### **12.3 Radiation Protection Design Features**

The information in this section of the reference ABWR DCD, including all subsections, tables, and figures, is incorporated by reference with the following departures and supplements.

Figure 12.3-74 Upper Drywell Shielding Radiation Dose Rates with Fuel Bundle on Refueling Bellows (Gy/h)

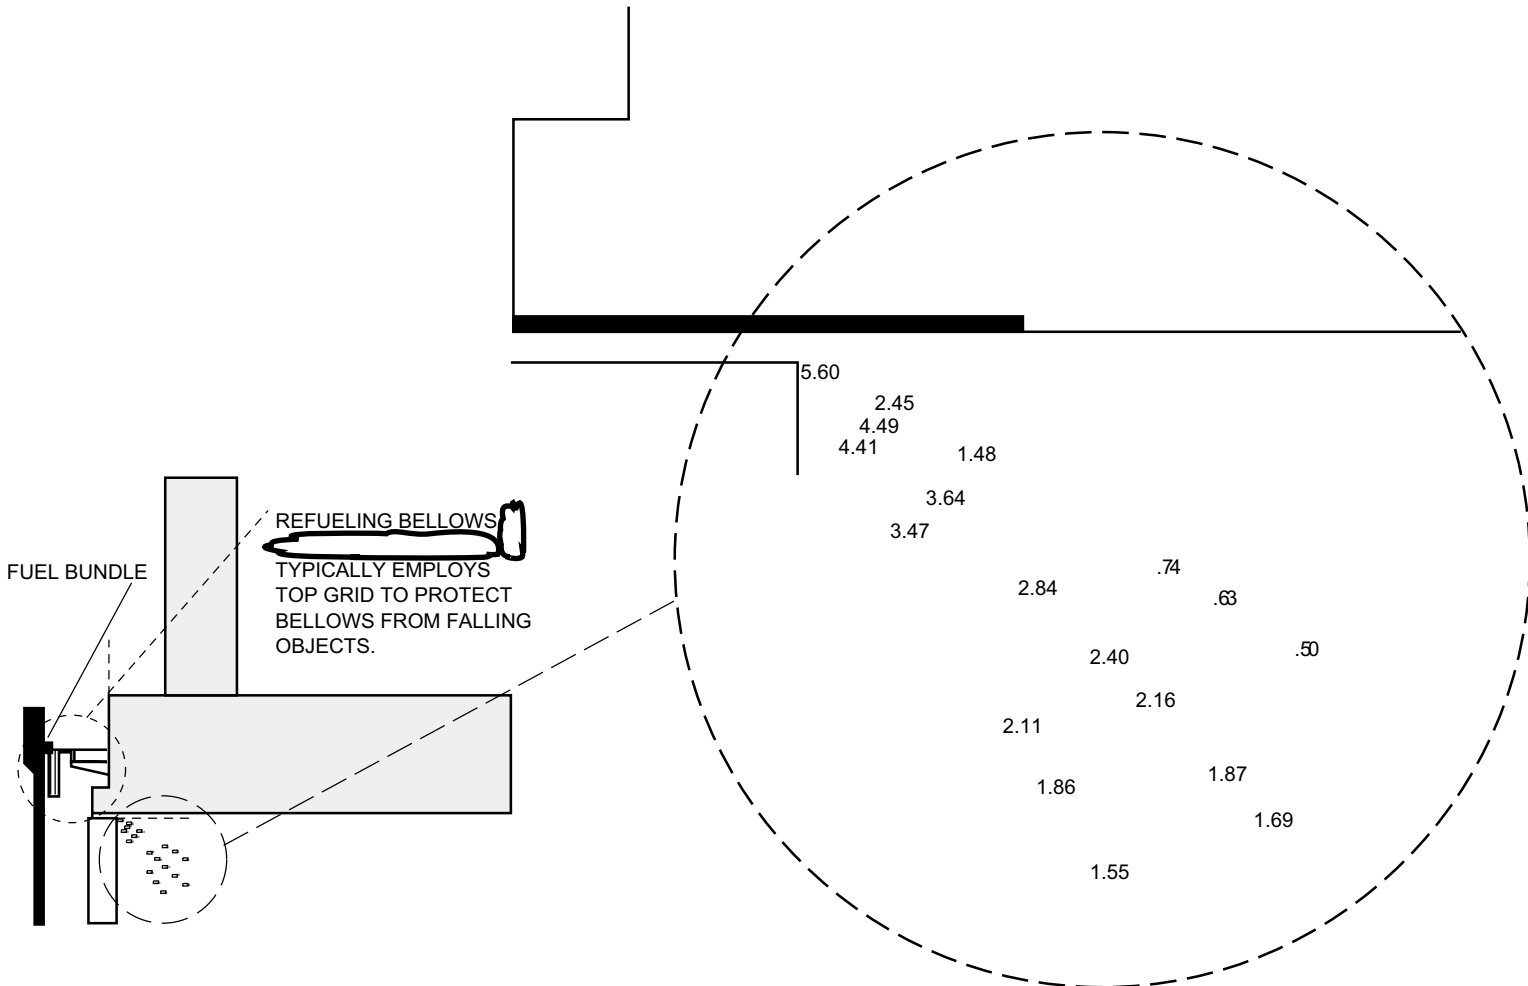
STD DEP Admin (Figures 12.3-1, 12.3-3, 12.3-6 and 12.3-74)
